Office Action Summary

09/954,806

AKASHI ET AL.

7. Claims 1-7 are rejected under 35 U.S.C. 102(b) as anticipated by or, in the alternative, under 35 U.S.C. 103(a) as obvious over the EP 997960 reference.

Figure 4 shows the thickness of a positive electrode active material layer wherein P represents the electrode layer (section 0119).

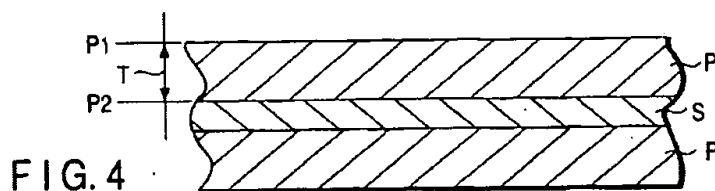
It is also disclosed that the positive electrode has a structure in which an electrode layer containing an active material is carried by one or both surfaces of the collector (section 0018). It is also disclosed that the negative electrode has a structure in which an electrode layer containing an active material is carried by one or both surfaces of the collector (section 0026)

The EP'960 reference teaches that the thickness of the positive electrode layer should be 10-100 μm ; it follows that where positive electrode layers are formed on both surfaces of the collector, one positive electrode layer has a thickness of 10-100 μm , naturally, the total thickness of the two positive electrode layers formed on both surfaces of the collector is 20-200 μm . It is

also disclosed that **the upper limit in the thickness is preferably 85 μm .** (section 0119/ 0158).

Hence, the EP'960 reference anticipates the claimed thickness, at least, from 80 to 100 μm when one layer is formed, and at least, from 80 to 200 μm when two layers are formed thereon.
